RE: **Response to Peer Review Comments**
The Village at Sudbury Station – 30 Hudson Road Sudbury, Massachusetts

MDM Transportation Consultants, Inc. (MDM) has prepared the following response to transportation-related peer review comments for the above-referenced project, as issued in a letter by the City's peer review consultant, Vanasse and Associates, Inc. (VAI), dated March 3, 2016. To facilitate review, specific comments are paraphrased with corresponding responses. Where appropriate, responses provided with input from the Applicant's design team are noted and include Sullivan Connors Associates (SCA) and Winn Residential (Winn).

Exhibit 4 *AutoTurn Analysis* *Sudbury Ladder Truck*

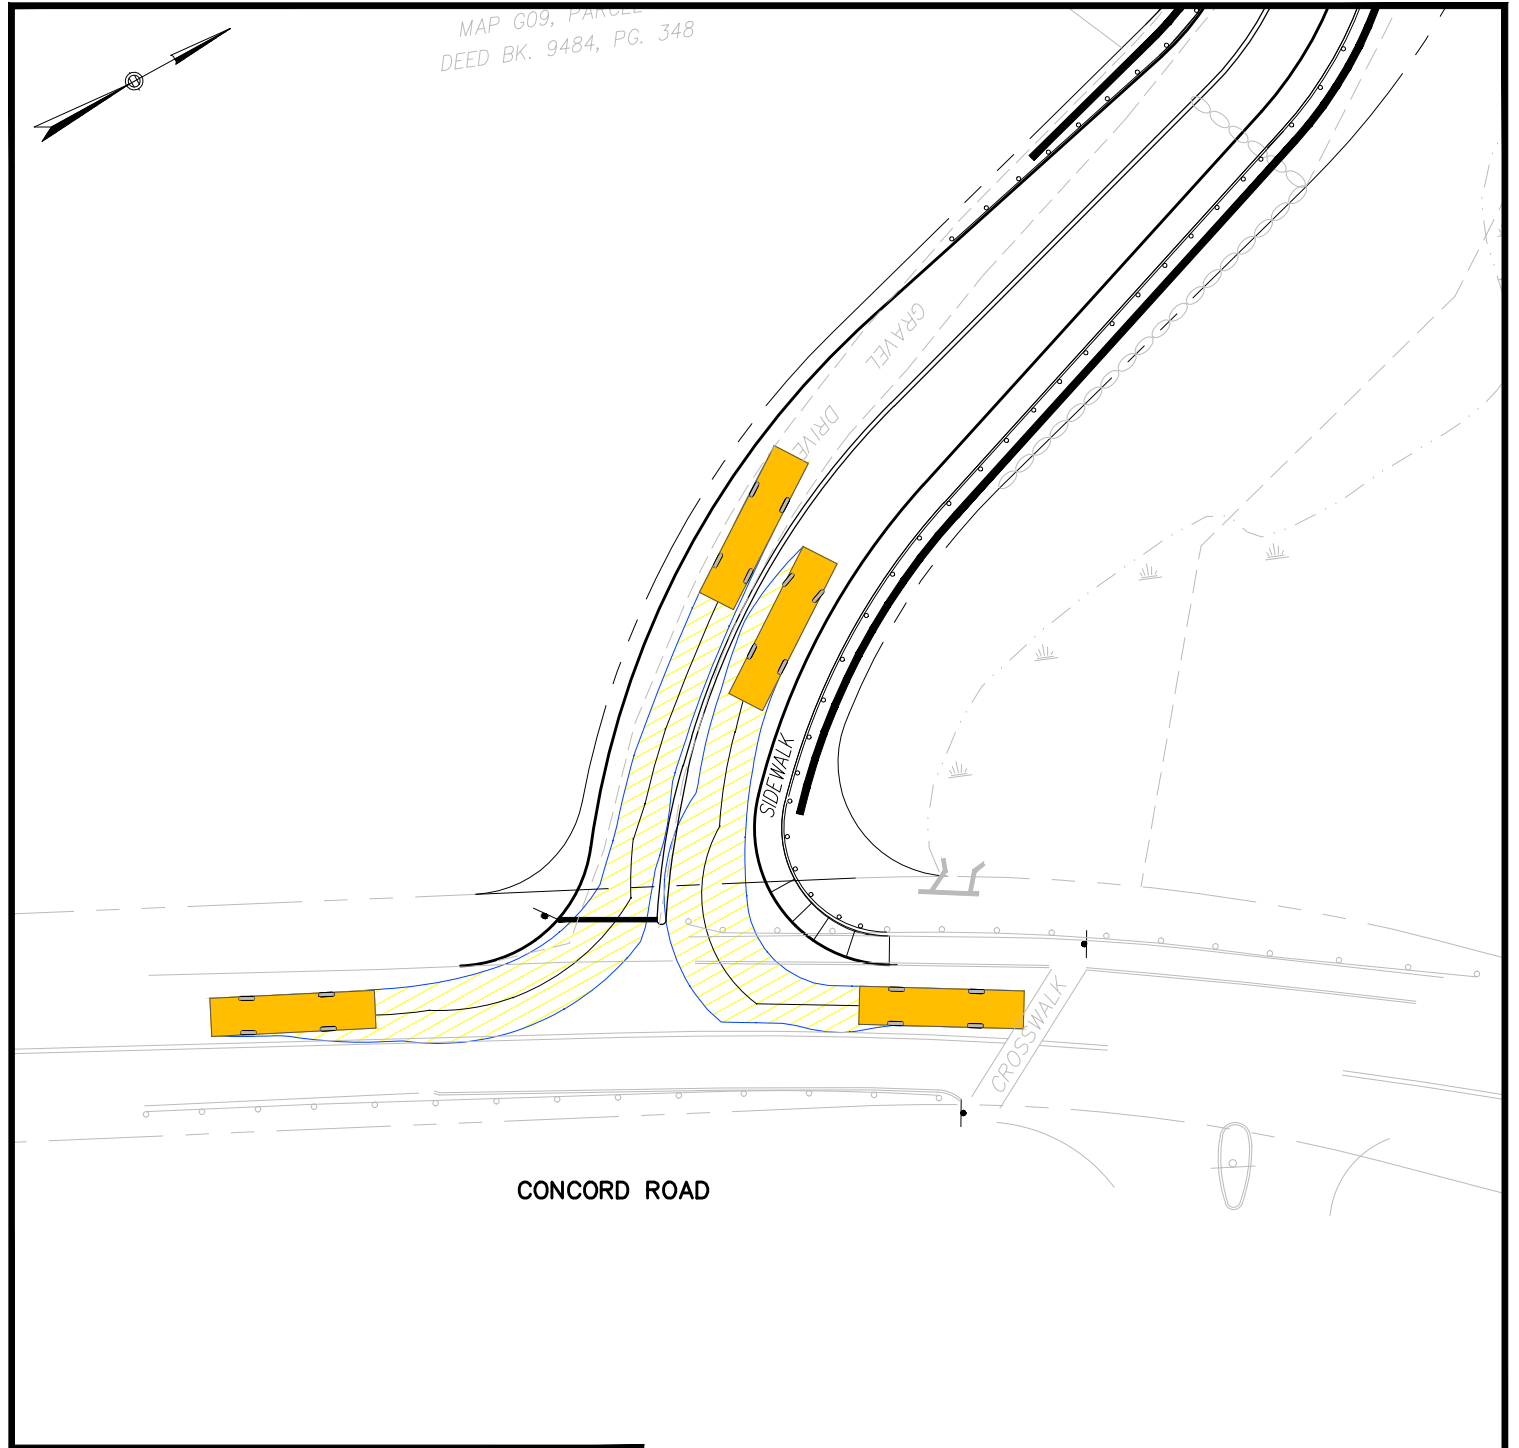
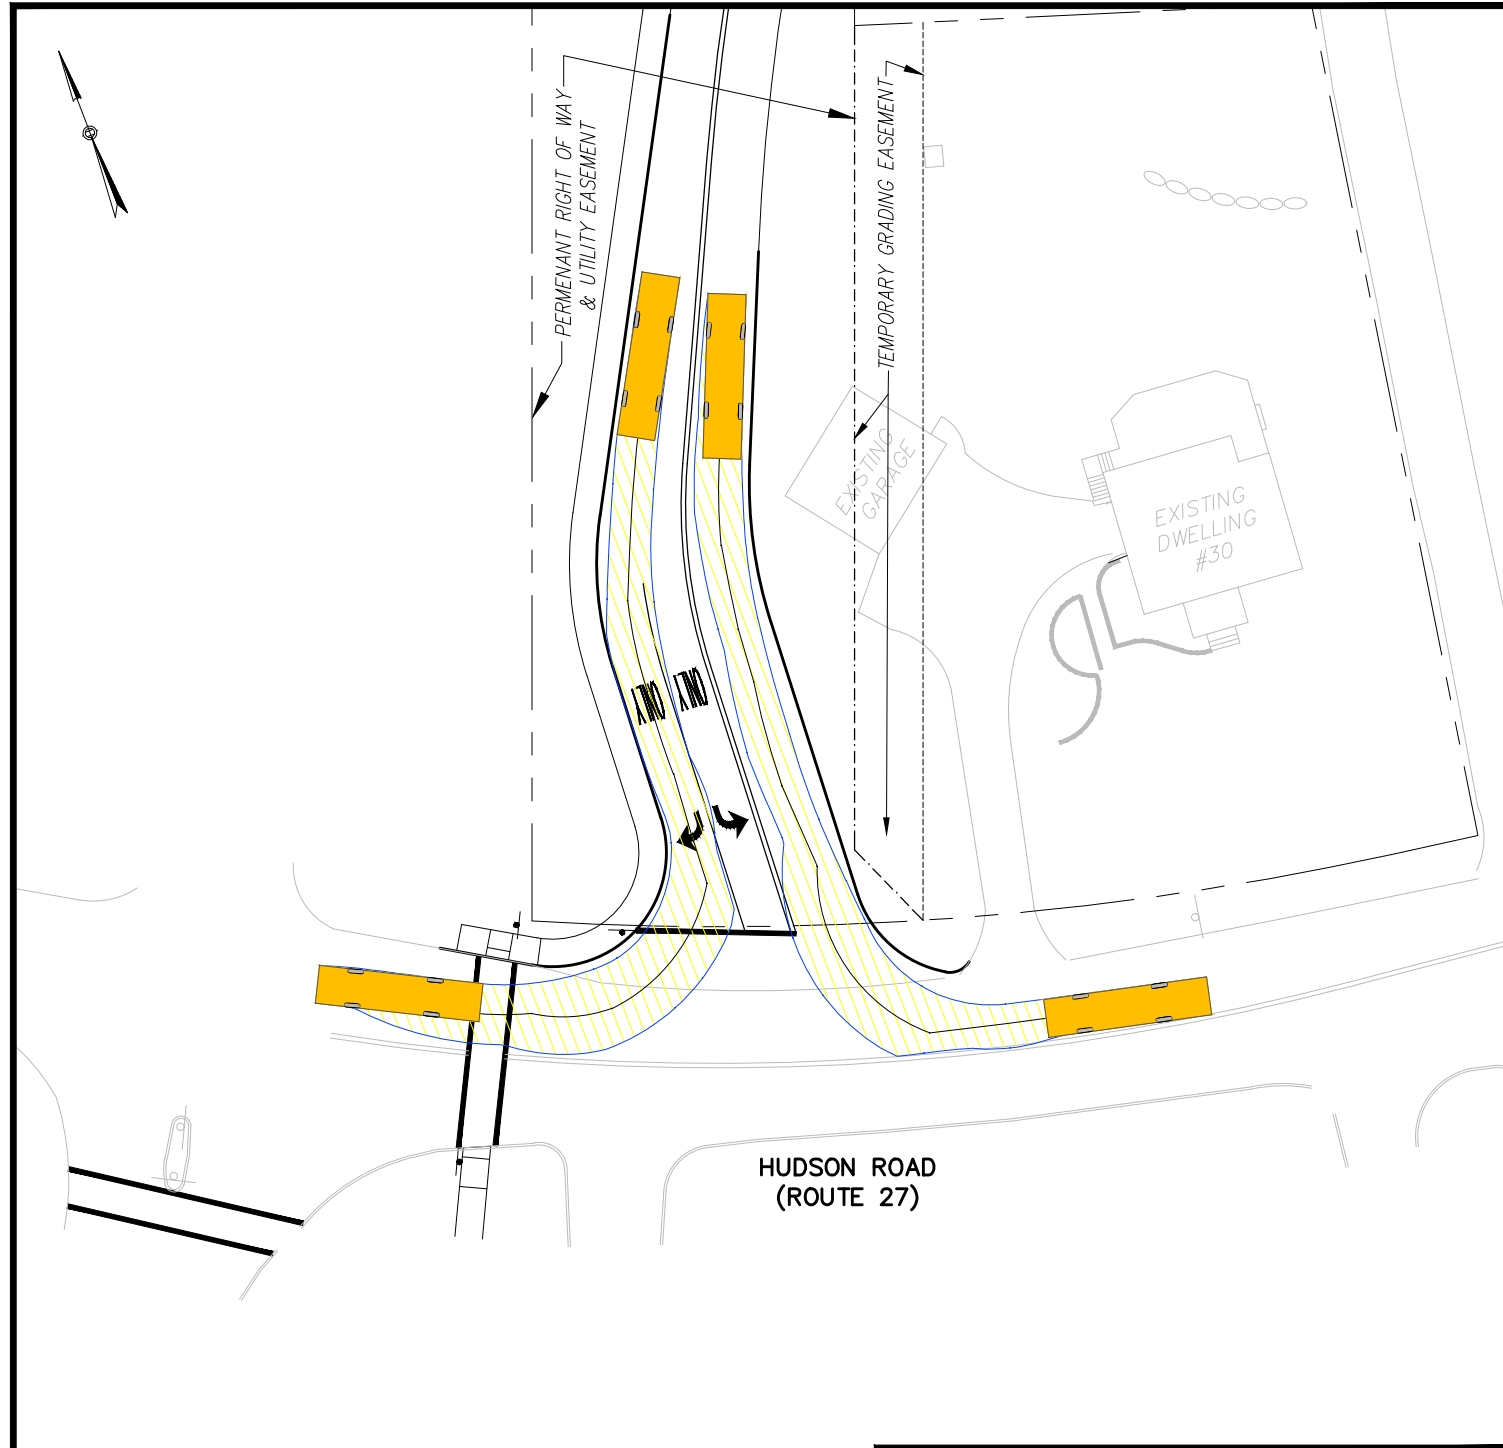
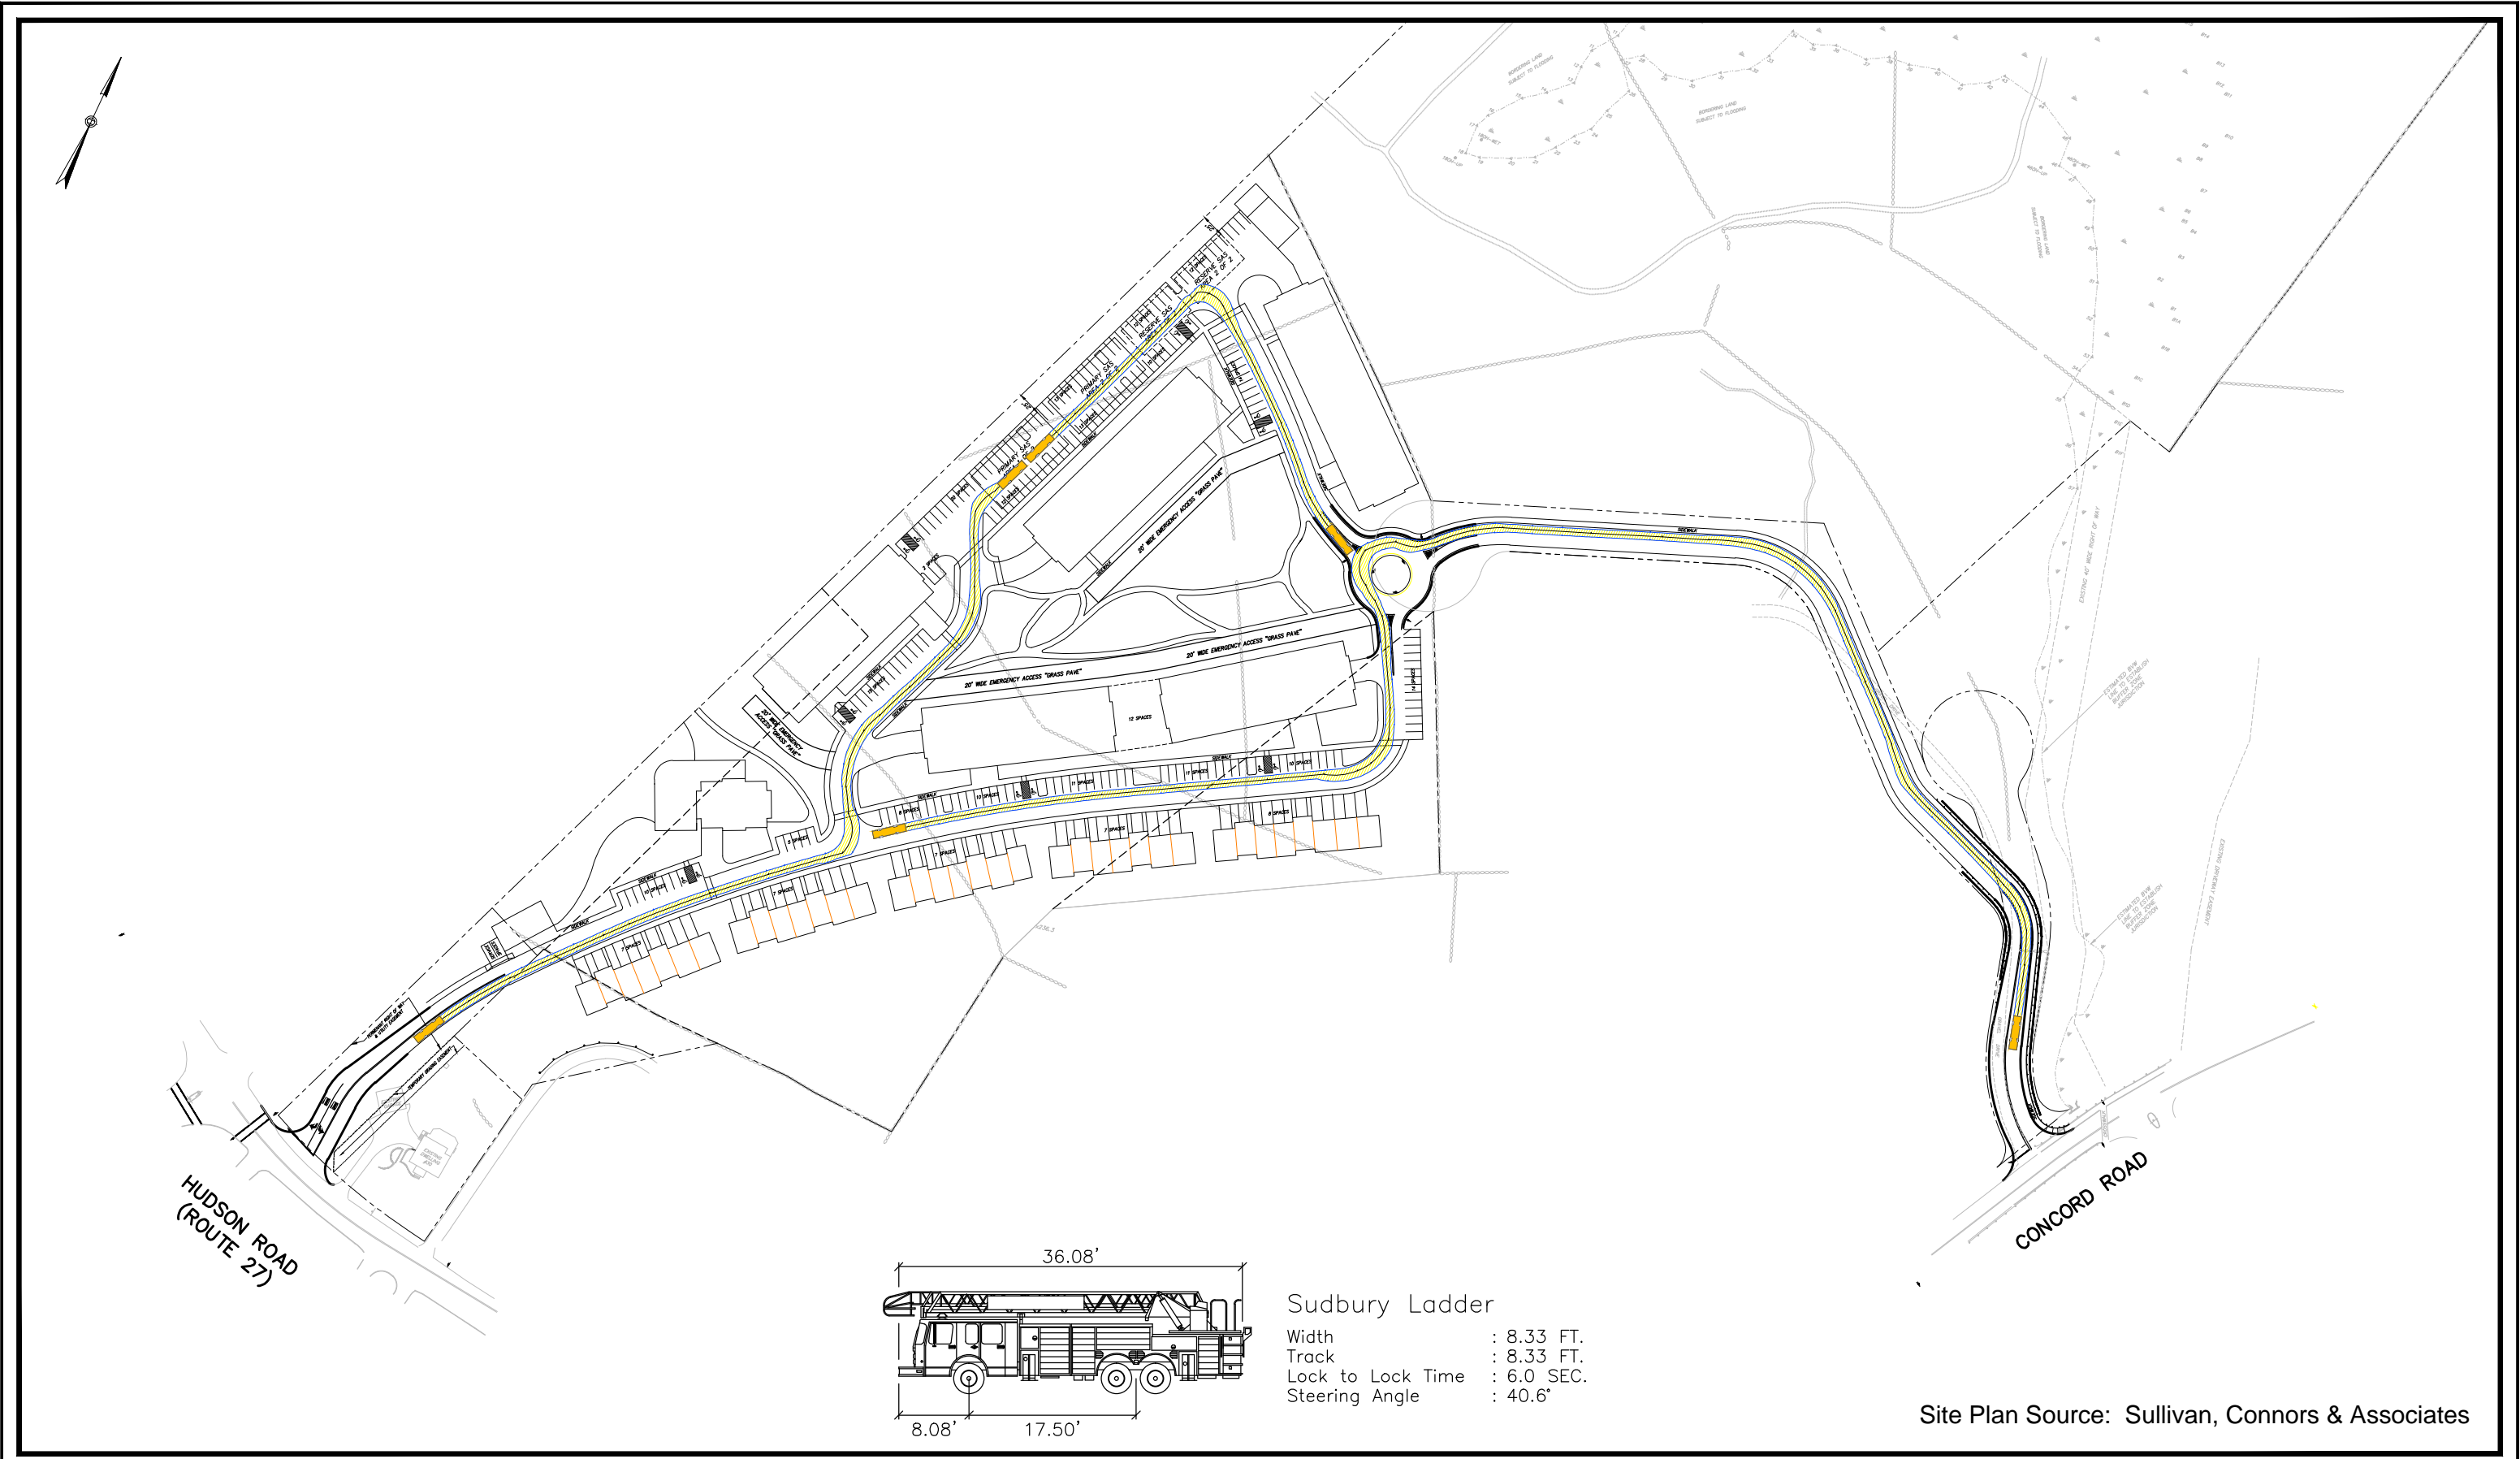
Comment T11: *"A truck turning analysis should be completed for the Project using the following design parameters as guidance: i) the analysis should be completed using the AutoTurn® or similar analysis software for the following design vehicles: an SU-30/40 (small delivery/moving vehicle and trash/recycling vehicle) and the Town of Sudbury Fire Department design vehicle; ii) the analysis should include the swept path for the front and rear tires of the design vehicles and any overhangs that may extend past the front and rear bumper of the vehicle (i.e., basket of the aerial ladder of the fire truck if so equipped); iii) the analysis should depict all maneuvers required to enter and exit the Project site by way of Route 27 and Concord Road (both left and right-turn movements entering and exiting), and all turning and maneuvering required within the Project site; iv) Back-up maneuvers, where required, should be clearly identified."*

Response: Requested AutoTurn® vehicle turn analysis has been conducted for the updated Site Plan of March 14, 2016 for a box truck (SU-40 design vehicle) and the Town's fire ladder truck. Resulting swept paths are depicted on **Exhibit 4** (Sudbury Ladder Truck at Site Driveways), **Exhibit 5** (Sudbury Ladder Truck within the Site), **Exhibit 6** (SU-40 Truck at Site Driveways) and **Exhibit 7** (SU-40 Truck within the Site). These exhibits show that ample roadway with and intersection geometry is provided to accommodate the swept path of these vehicle types.
